STATE OF HAWAII
DEPARTMENT OF TRANSPORTATION
HIGHWAYS DIVISION

ROADWAY PLANS

FARRINGTON HIGHWAY RESURFACING

Federal Aid Project No. STP-093-1(026)

SHEET No. 5 OF 14 SHEETS

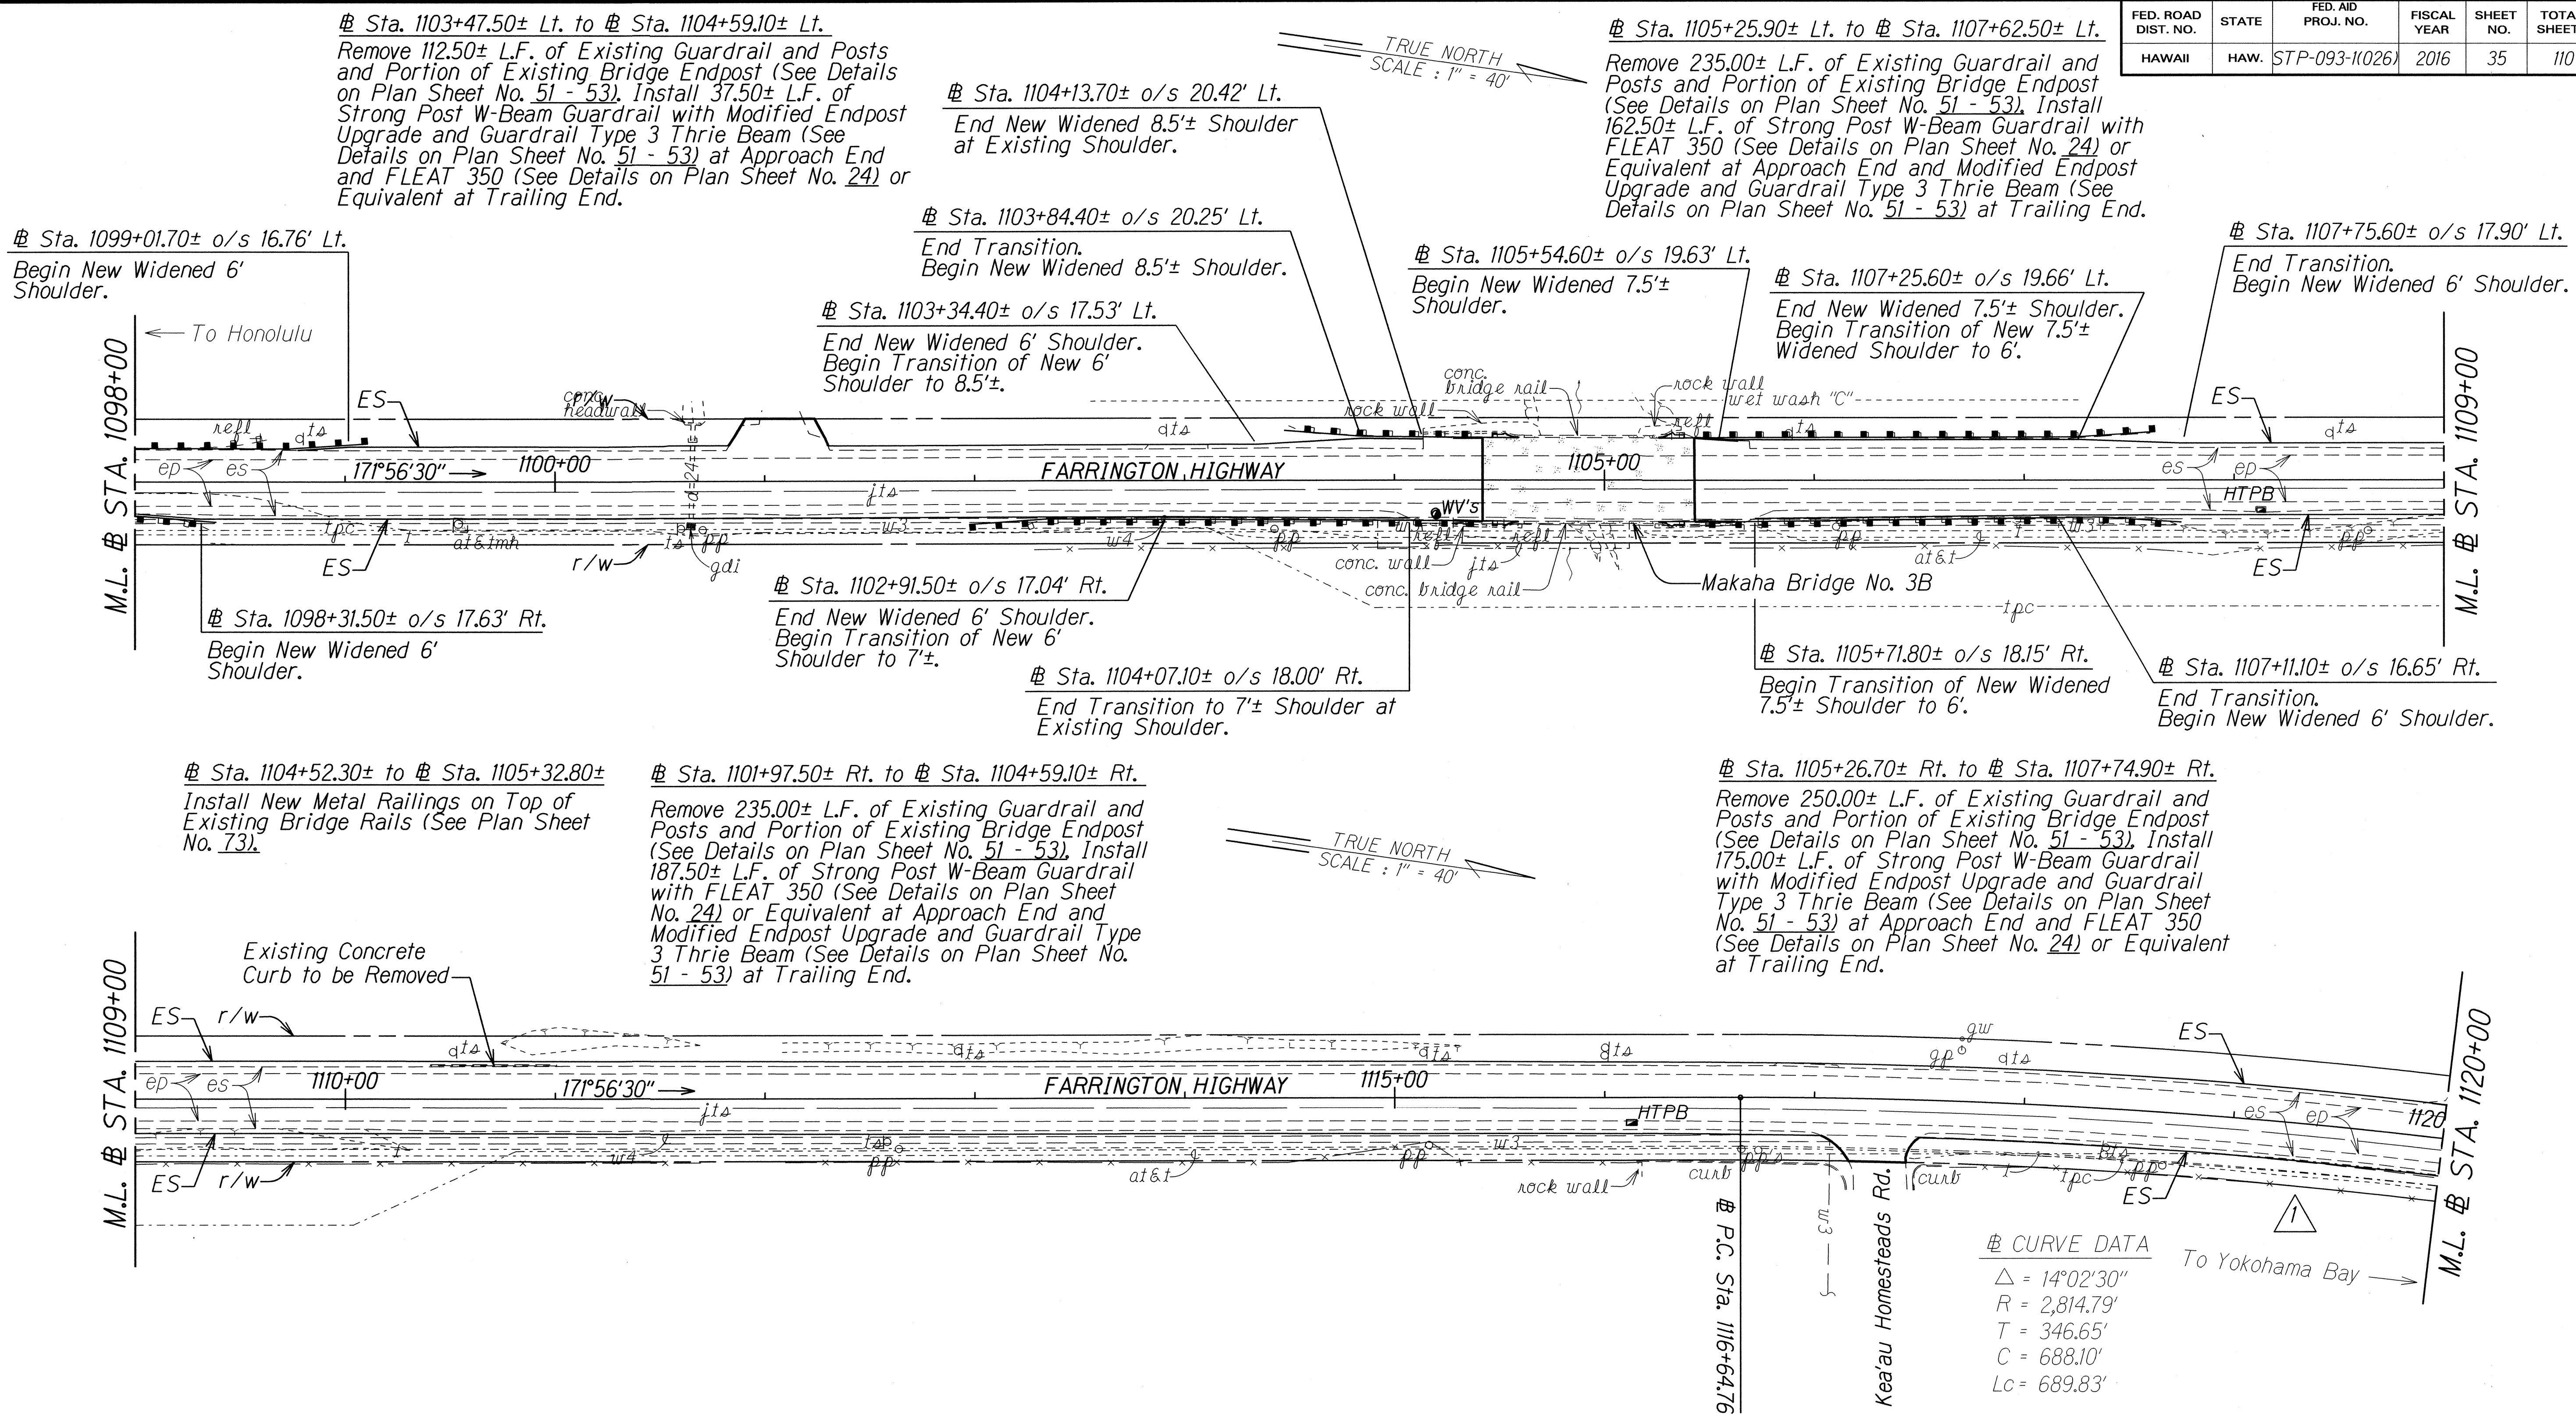
6/2/16 Revised es arrow to point to correct line.

SHEET No. 9 OF 14 SHEETS

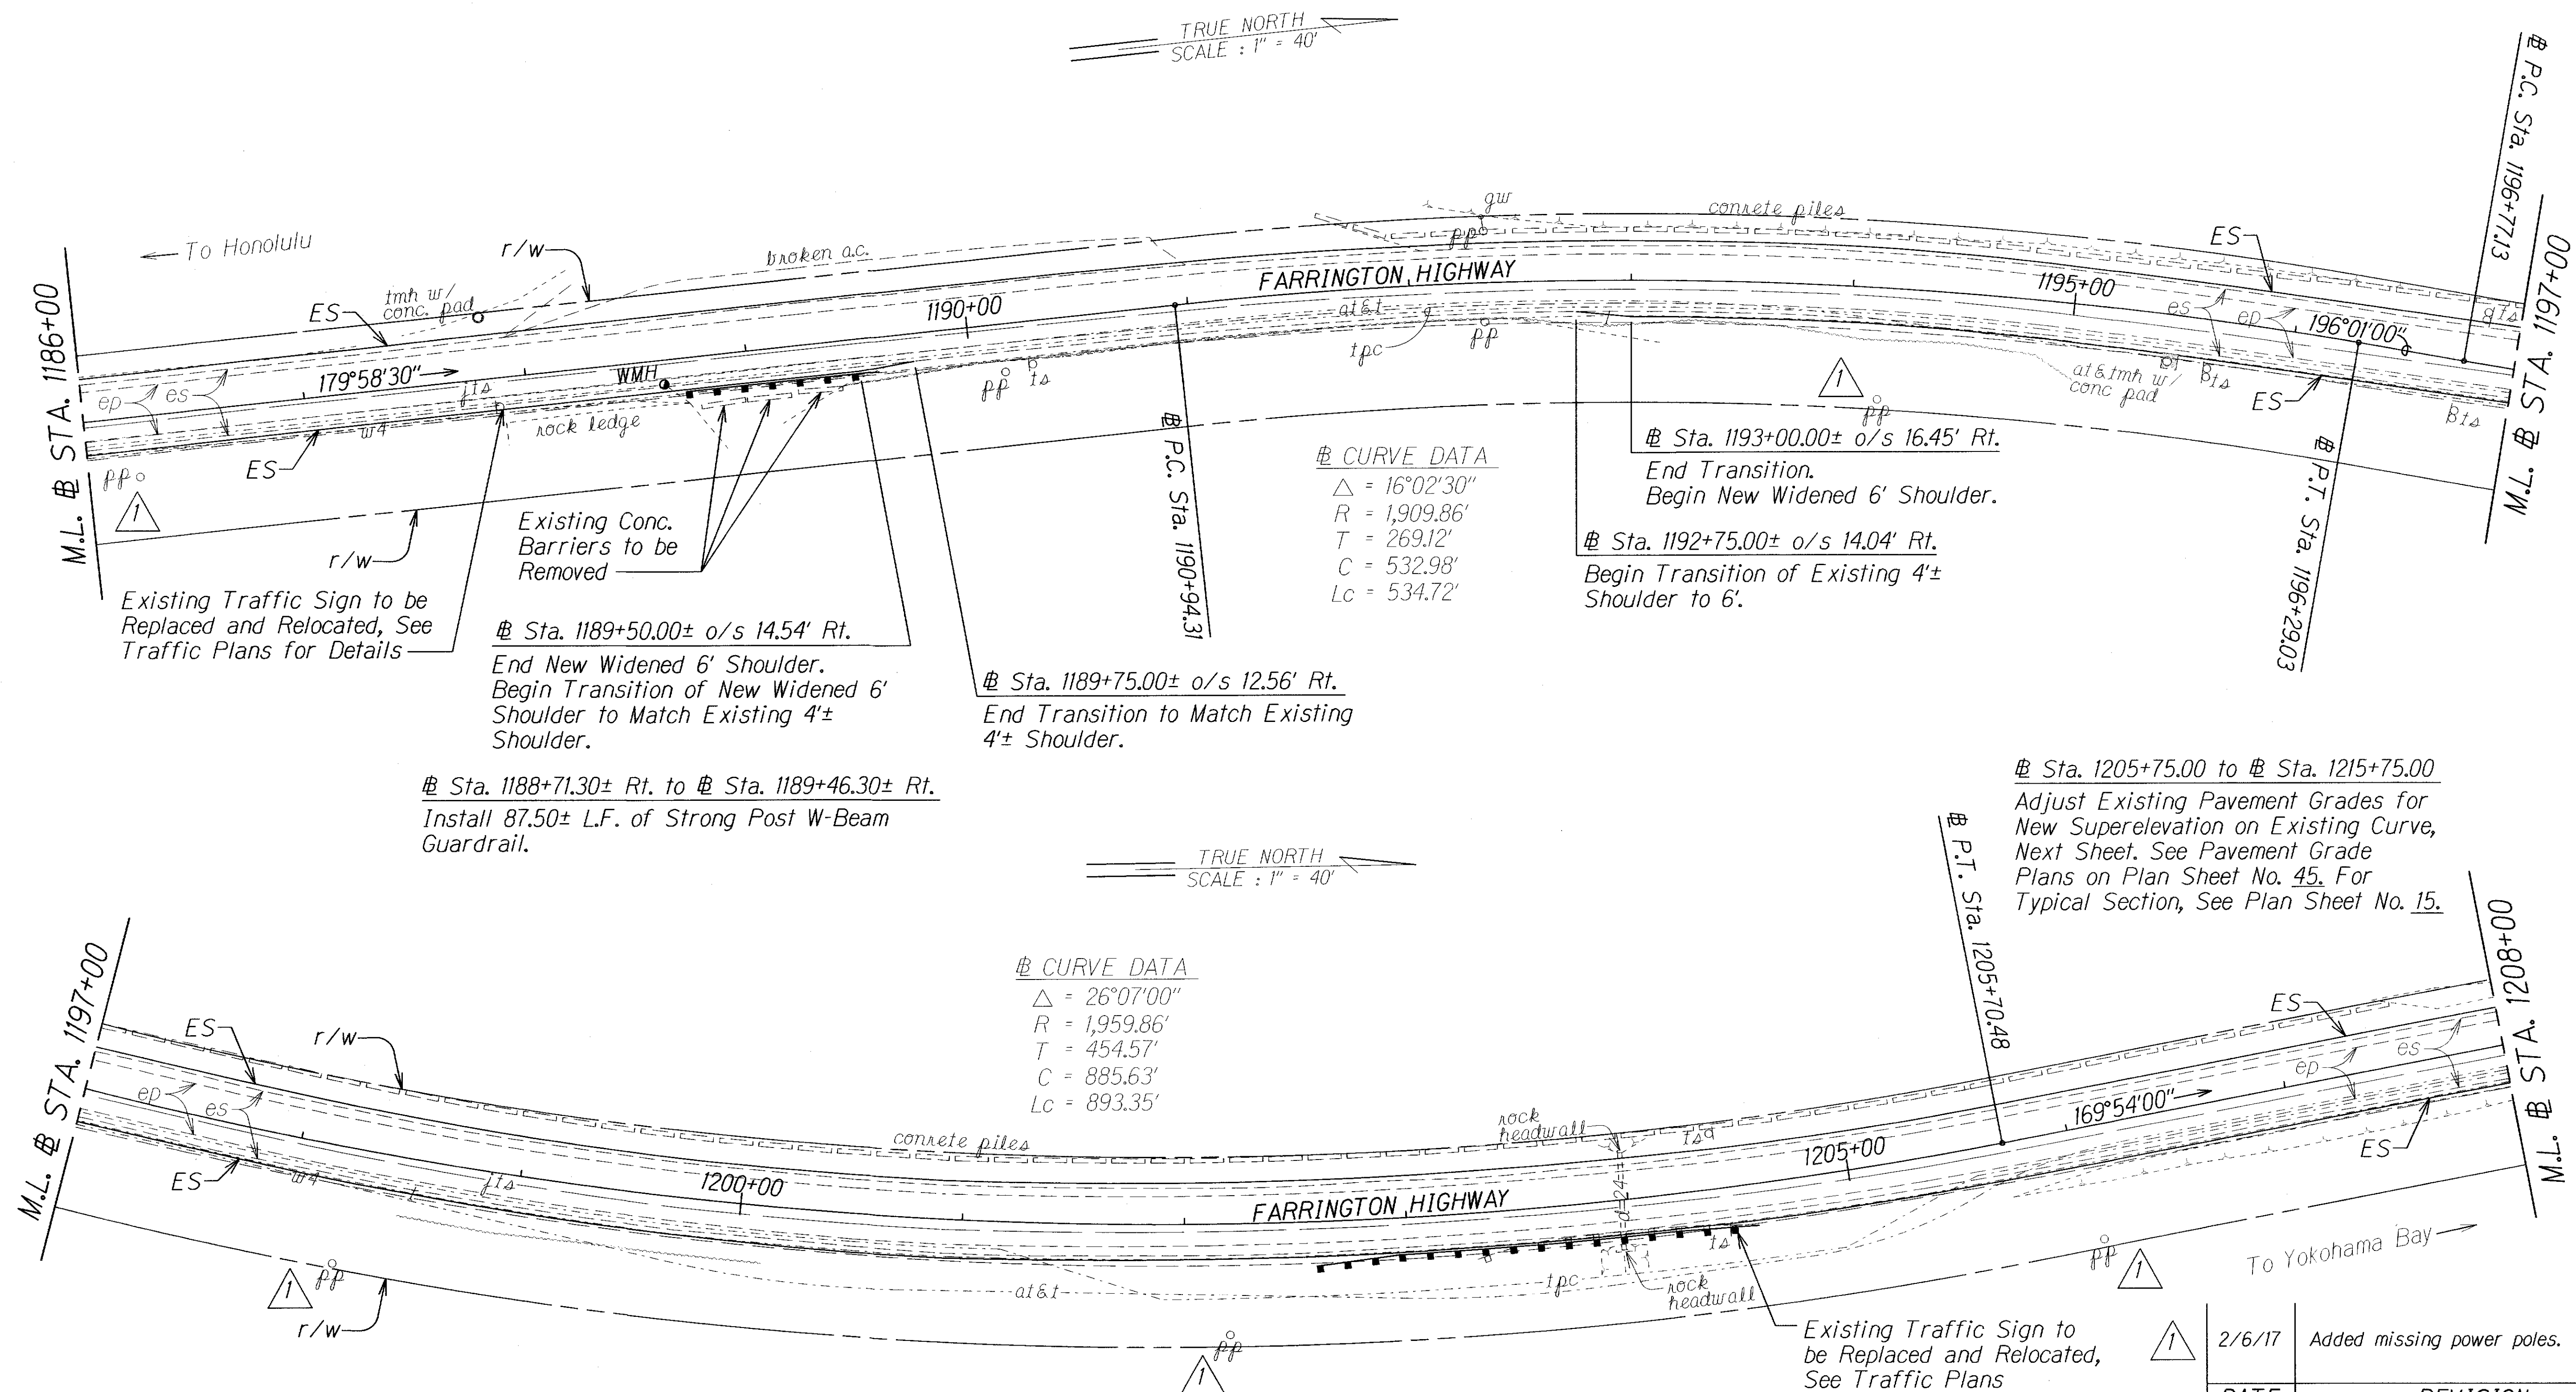
DATE	REVISION
2/6/17	Added missing power poles.

STATE OF HAWAII
DEPARTMENT OF TRANSPORTATION
HIGHWAYS DIVISION
ROADWAY PLANS
FARRINGTON HIGHWAY RESURFACING
Vicinity of Kili Drive to
Satellite Tracking Station Road
Federal Aid Project No. STP-093-1(026)
Scale 1"=40' Date: April, 2016
SHEET No. 12 OF 14 SHEETS

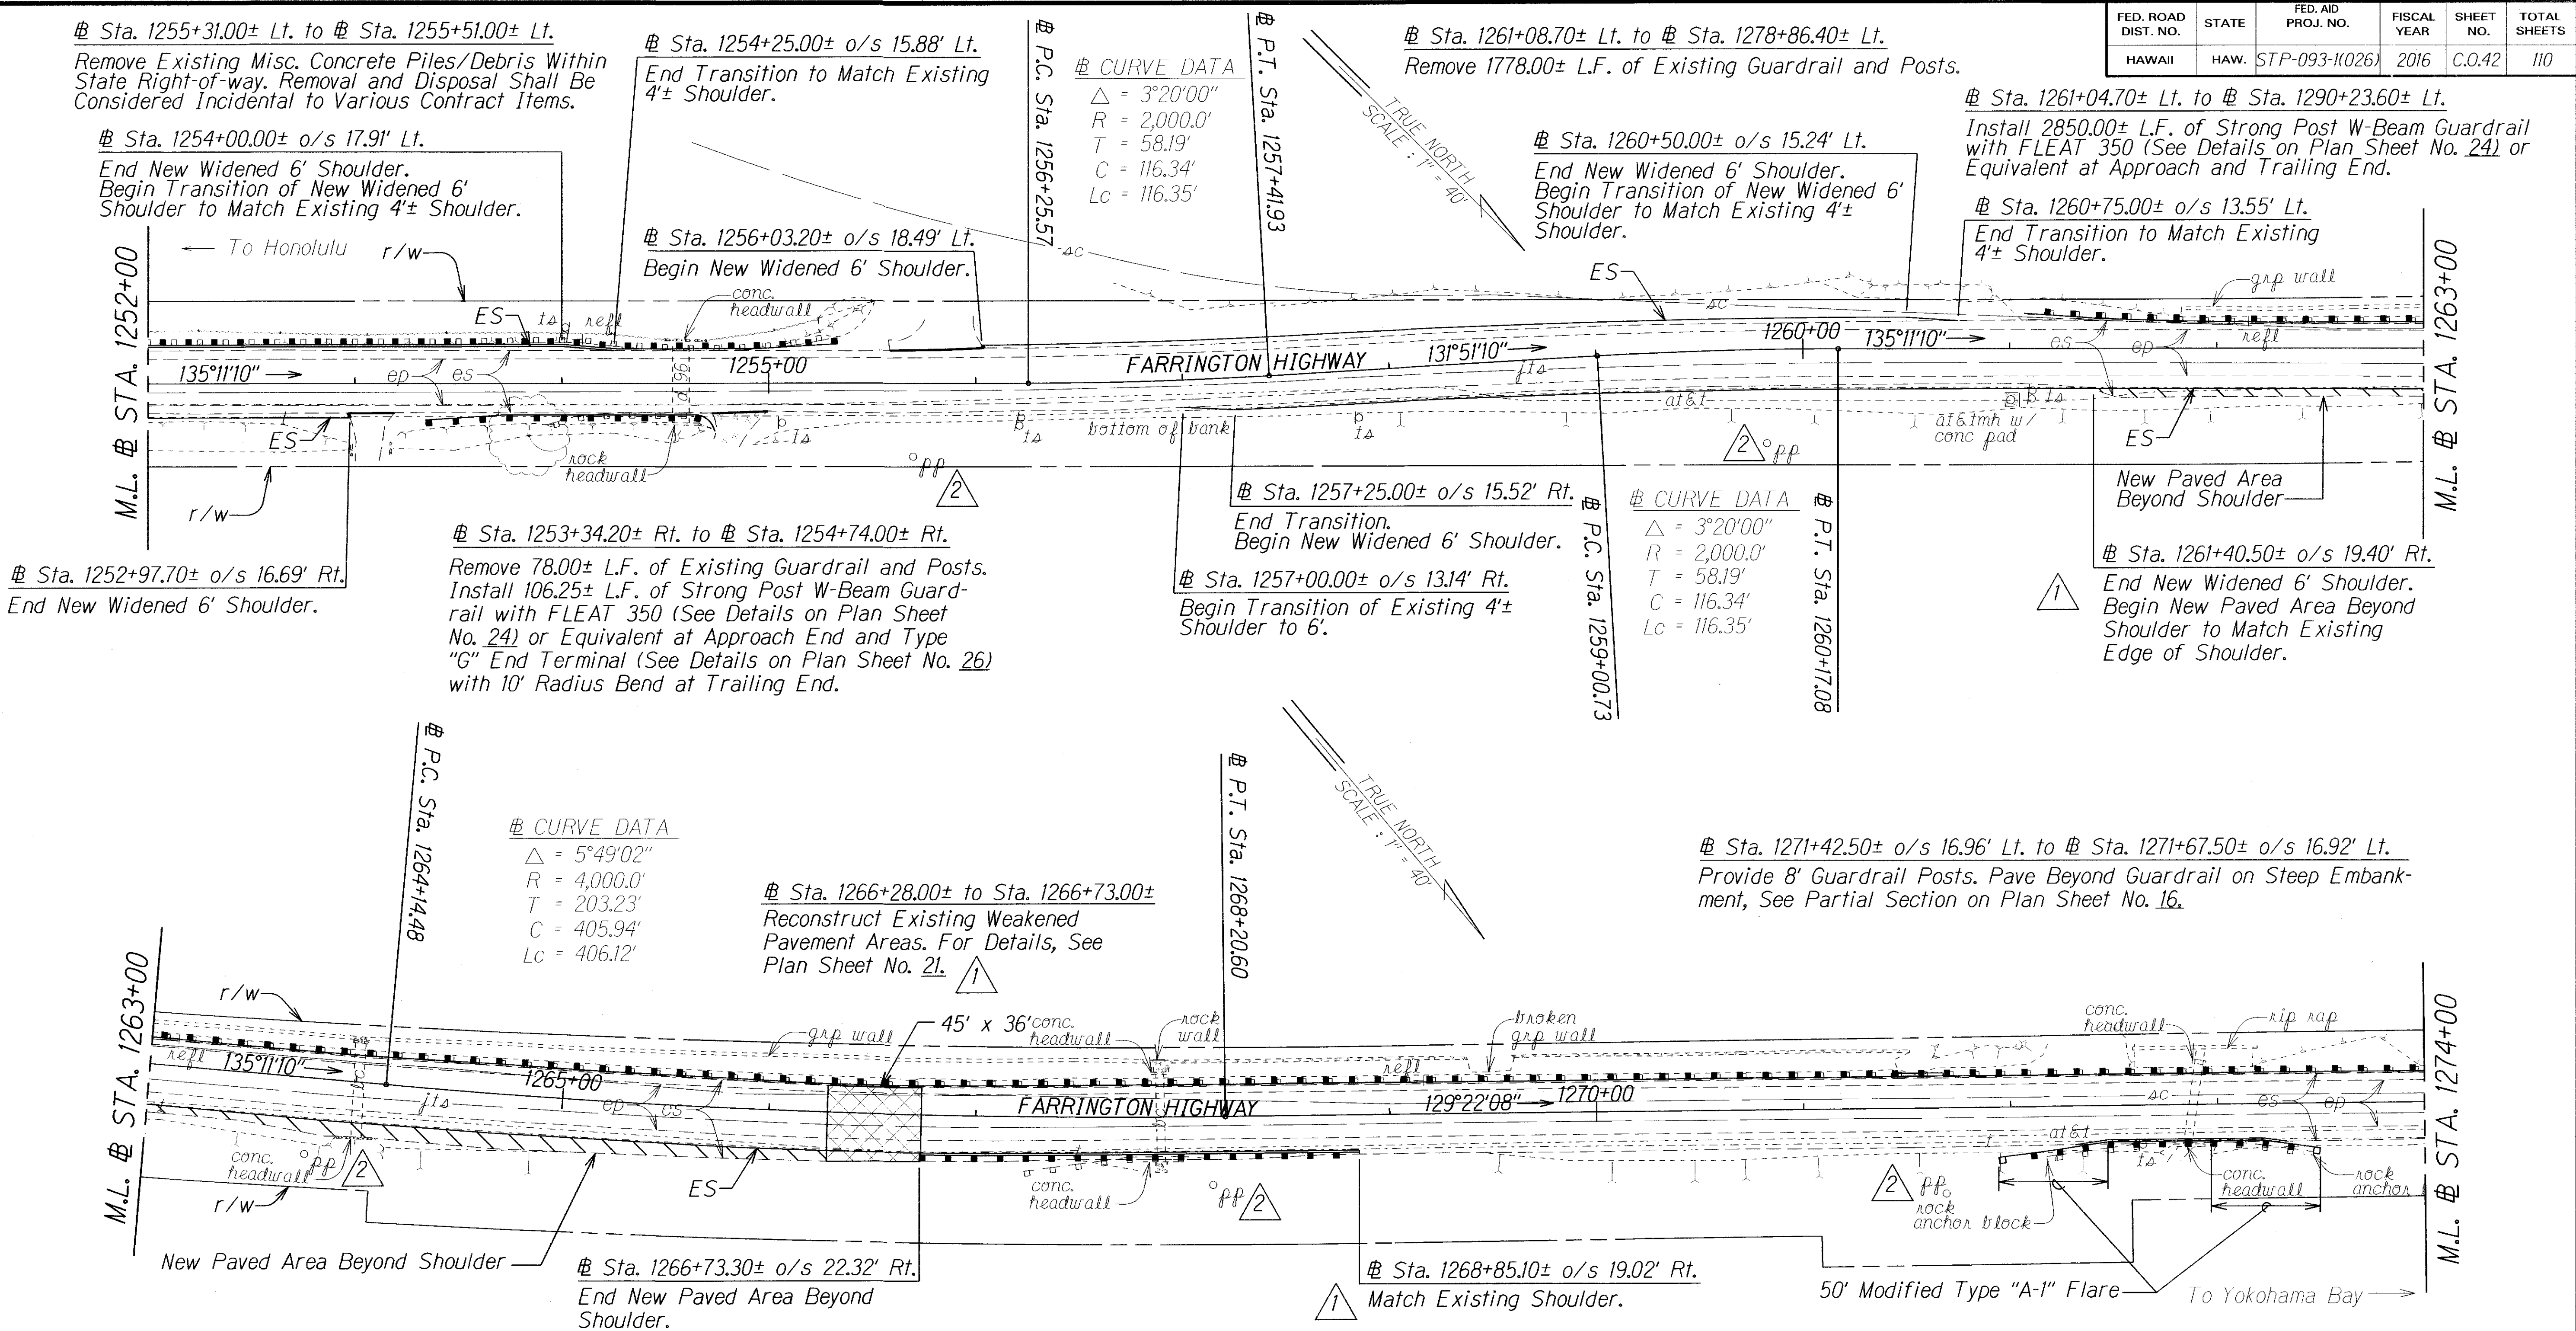
DATE	REVISION
2/6/17	Added missing power poles.
6/2/16	Revised location for end of new widened 6' shoulder. Revised reference sheet no. for reconstruct existing weakened pavement details.
